UNITED STATES DEPARTMENT OF COMMERCE United States Patent and Trademark Office Address: COMMISSIONER FOR PATENTS P.O. Box 1450 Alexandria, Virginia 22313-1450 www.uspto.gov

APPLICATION NO.	FILING DATE	FIRST NAMED INVENTOR	ATTORNEY DOCKET NO.	CONFIRMATION NO.
09/876,396	06/07/2001	Syuuichi Kariyazaki	14701	7345
	7590 10/29/200 ГТ MURPHY & PRE S		EXAMINER	
400 GARDEN CITY PLAZA SUITE 300 GARDEN CITY, NY 11530			MATTHEWS, COLLEEN ANN	
			ART UNIT	PAPER NUMBER
			2811	
			MAIL DATE	DELIVERY MODE
			10/29/2009	PAPER

DETAILED ACTION

Annotated Figure 14

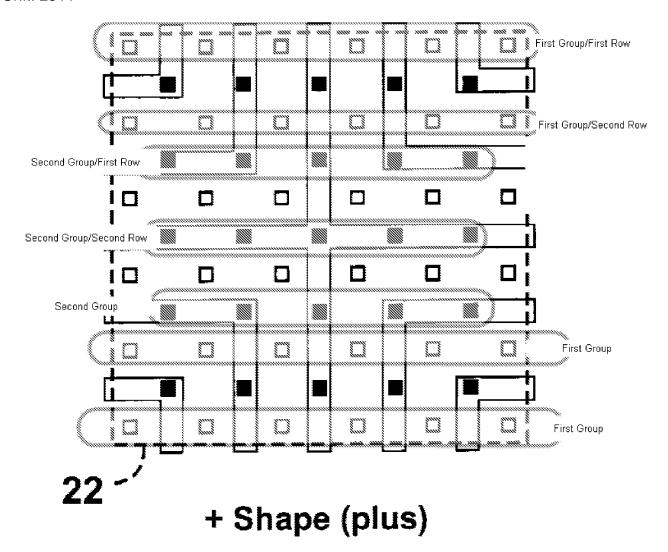
the first group of I/O cells arranged in a first row and a second row (see annotated Fig 14 below, "First group/First row" and "First group/Second row", for example) disposed on an inner position relative to the first row

the second group of I/O cells arranged in a first row and a second row (see annotated Fig 14 below, "Second group/First row" and "Second group/Second row", for example) disposed on an inner position relative to the first row;

Regarding claim 10, Moresco discloses a semiconductor device, wherein at least one of the first group (see Fig 14- first group considered as the white squares corresponding to ground pads) and the second group (see Fig 14- first group

considered as the black squares corresponding to power pads) includes an outer group (see Fig 14- first group considered as the white squares corresponding to ground pads) and inner group (see Fig 14- first group considered as the black squares corresponding to power pads) disposed on the inner position of the mounting member with respect to the outer group (see Fig. 14, the center black square/power pad is disposed in an inner group).
